Scientific Analysis/Calculation Administrative Change Notice

1. Document Number:	ANL-NBS-HS-000047	2. Revision:	01	3. ACN:	01
4. Title:	THC Sensitivity Study of Heterogeneous Permeability and Capillarity Effects				
5. No. of Pages Attached:	35

Figure 6.3-1. Schematic Representation of Seepage into an Emplacement Drift Situated in Unsaturated Fractured Rock

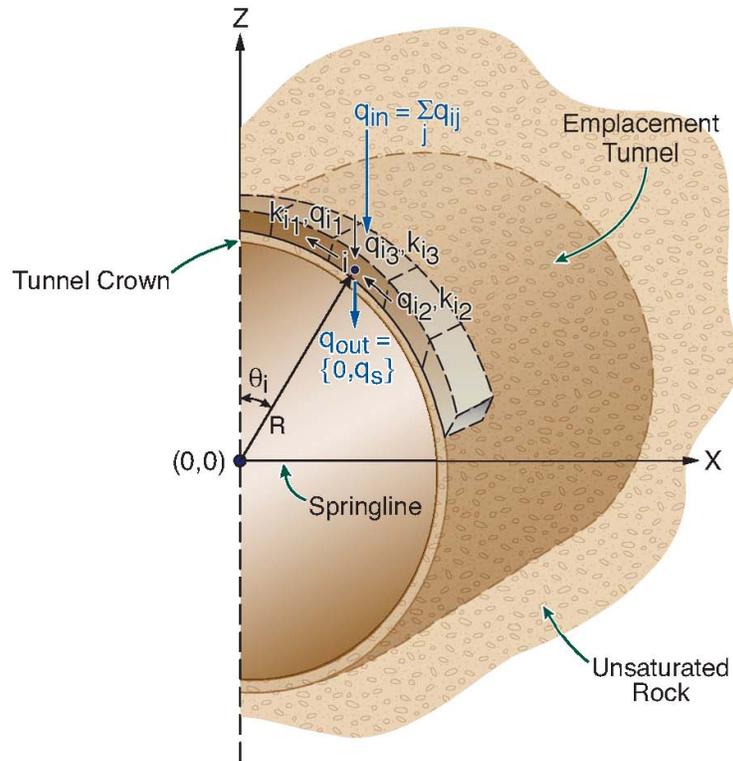
6-10	Figure 6.3-1: Replaced “Tunnel” with “Drift” in figure caption.				
6-14	Section 6.4.2, first paragraph: Replaced “tunnel” with “drift” in next-to-last sentence.				
6-18	Section 6.4.6, first paragraph: Replaced “tunnels” with “drifts” in last sentence.				
6-28	Section 6.4.11.2, first paragraph, second bulleted item: Replaced “tunnels” with “drifts”. Section 6.4.11.2, second paragraph: Replaced “tunnel” with “drift” in second sentence.				
6-29	First bulleted item: Replaced “tunnel” with “drift”.				
6-38	Section 6.5.1, first paragraph: Added the following after second sentence: “The numerical difficulty encountered by this simulation is specific to this simulation only, and has no impact on other simulations in this report. Recollect that different realizations of the same fracture permeability distribution are used in this report. For this particular simulation with Realization # 1 of the permeability distribution, the initial permeability of a few gridblocks and their spatial/temporal evolution were such that it resulted in a singular matrix in the chemical solver routine of the software TOUGHREACT. Thus non-convergence for this simulation was not because of any coding or data-entry error but because of a rare occurrence.”

Figure 6.6-3. Comparison of Seepage Fluxes from Ambient (Simulation ID: “base_r2_10x_lev_amb”), TH (Simulation ID “base_r2_10x_lev_th.”), and THC (Simulation ID: “base-r2_10x_lev_thc”) Simulations with IMF10 Infiltration Fluxes

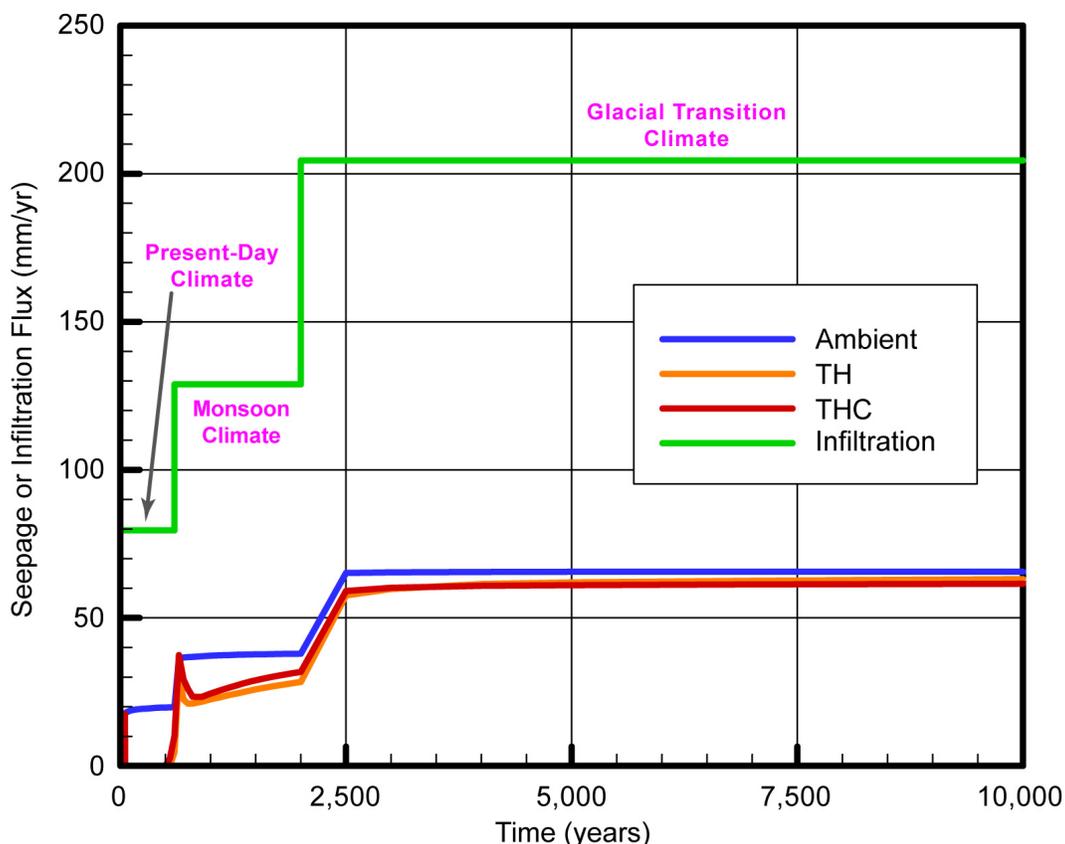
1. Document Number:	ANL-NBS-HS-000047	2. Revision:	01	3. ACN:	01
4. Title:	THC Sensitivity Study of Heterogeneous Permeability and Capillarity Effects				
6-48	Figure 6.6-3: Replaced existing figure to remove climate-period demarcations; added “with IMF10 Infiltration Fluxes” at the end of figure caption; deleted sentence “The vertical violet lines are used to distinguish the different climatic periods and they do not represent any seepage data” in figure note. Section 6.6.2, first paragraph, lines 3 and 4: Added “effect” after “capillary-barrier”. Section 6.6.2, second paragraph, line 4: Changed “simulations shows” to “simulations show”.				
6-49	Section 6.6.2, second bulleted item, last line: Added “computed” after “capillary-barrier effects”.				
6-53	Section 6.6.3, fourth paragraph, fifth line: Changed “though” to “through”.				
6-74	Figure 6.7-1: Replaced existing figure to remove climate-period demarcations; added “with IMF10 Infiltration Fluxes” at the end of figure caption; deleted sentence “The vertical violet lines are used to distinguish the different climatic periods and they do not represent any seepage data” in figure note.

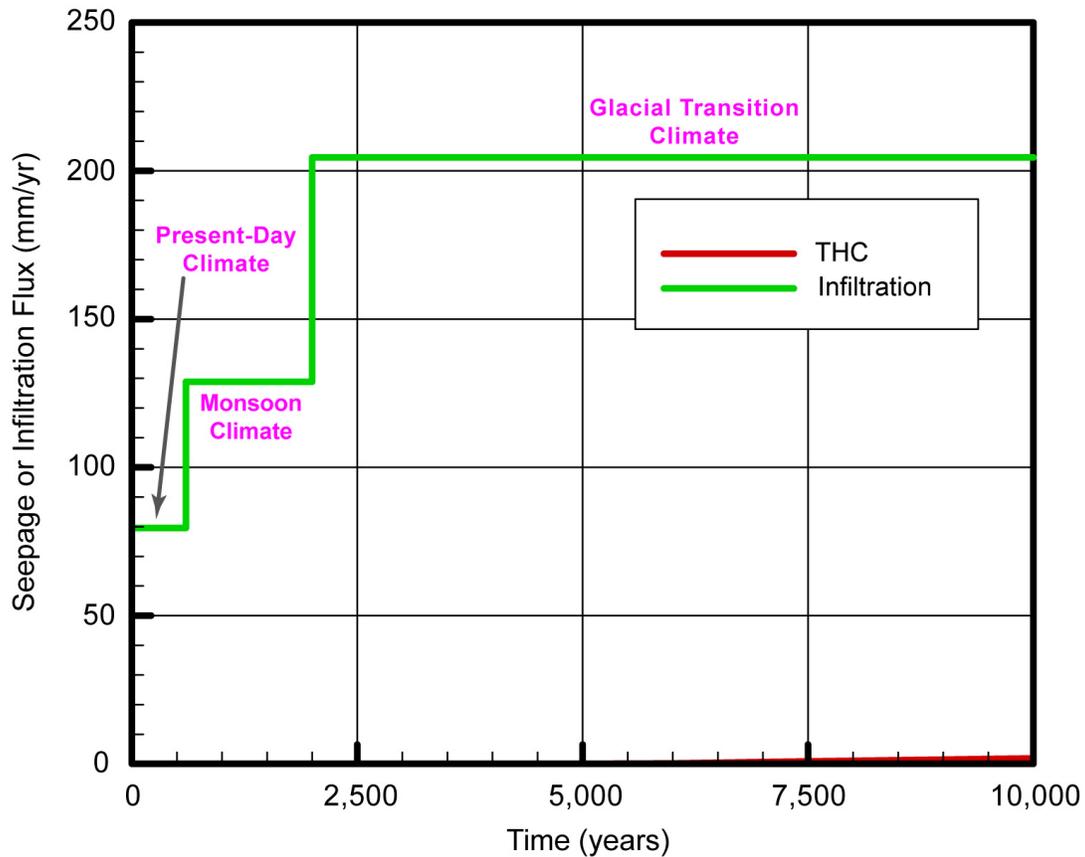
6-75	Figure 6.7-2: Replaced existing figure to remove climate-period demarcations; added “with IMF10 Infiltration Fluxes” at the end of figure caption; deleted sentence “The vertical violet lines are used to distinguish the different climatic periods and they do not represent any seepage data” in figure note.				
6-76	Figure 6.7-3: Replaced existing figure to remove climate-period demarcations; added “with IMF10 Infiltration Fluxes” at the end of figure caption; deleted sentence “The vertical violet lines are used to distinguish the different climatic periods and they do not represent any seepage data” in figure note.				
6-82	Figure 6.7-4: Replaced existing figure to remove climate-period demarcations; added “with IMF10 Infiltration Fluxes” at the end of figure caption; deleted sentence “The vertical violet lines are used to distinguish the different climatic periods and they do not represent any seepage data” in figure note.

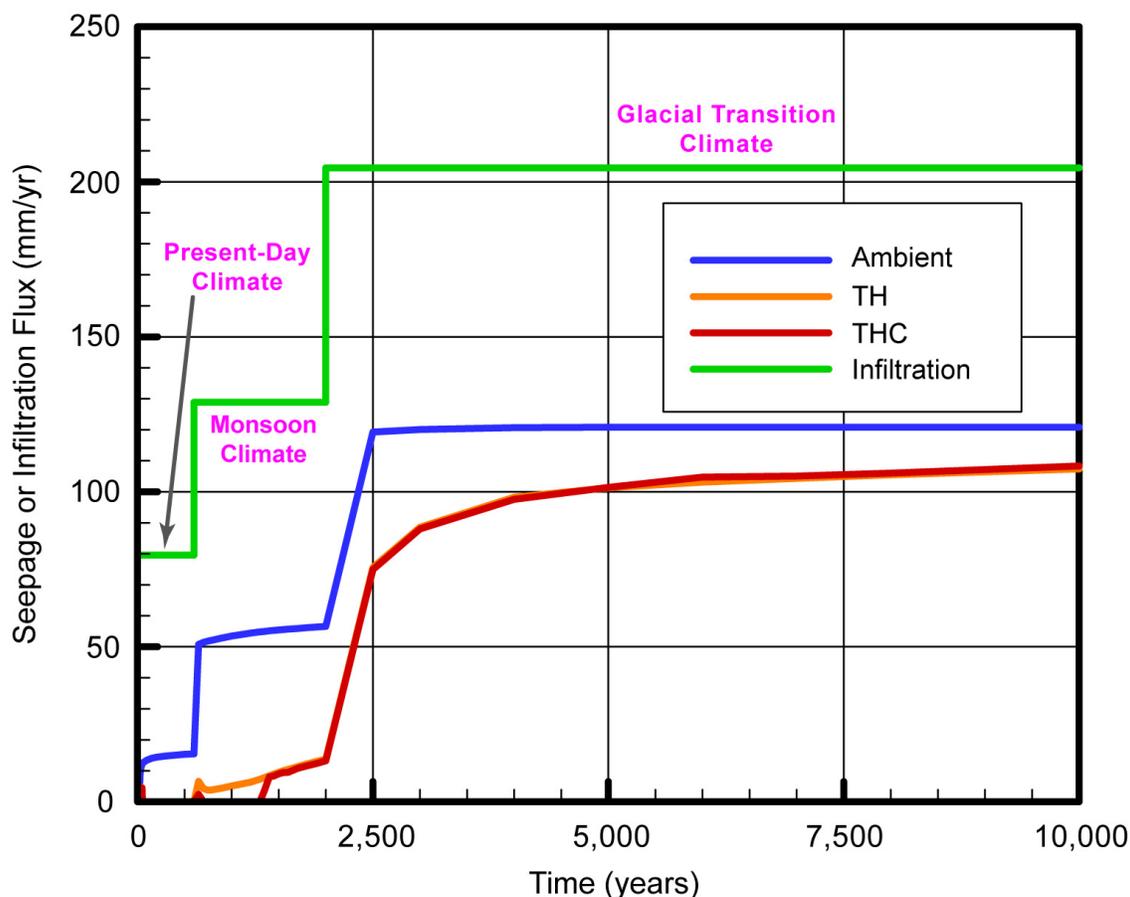
6-83	Figure 6.7-5: Replaced existing figure to remove climate-period demarcations; added “with IMF10 Infiltration Fluxes” at the end of figure caption; deleted sentence “The vertical violet lines are used to distinguish the different climatic periods and they do not represent any seepage data” in figure note.				
6-84	Figure 6.7-6: Replaced existing figure to remove climate-period demarcations; added “with IMF10 Infiltration Fluxes” at the end of figure caption; deleted sentence “The vertical violet lines are used to distinguish the different climatic periods and they do not represent any seepage data” in figure note.				
6-90	Section 6.10, first paragraph, second to last sentence: Replaced existing sentence with “These simulations improve confidence with regard to seepage estimation under THC conditions”. Section 6.11, second paragraph, third sentence: Replaced existing sentence with “As mentioned in Section 1.1, the objective of these sensitivity studies is to improve confidence in the abstraction of drift seepage”.
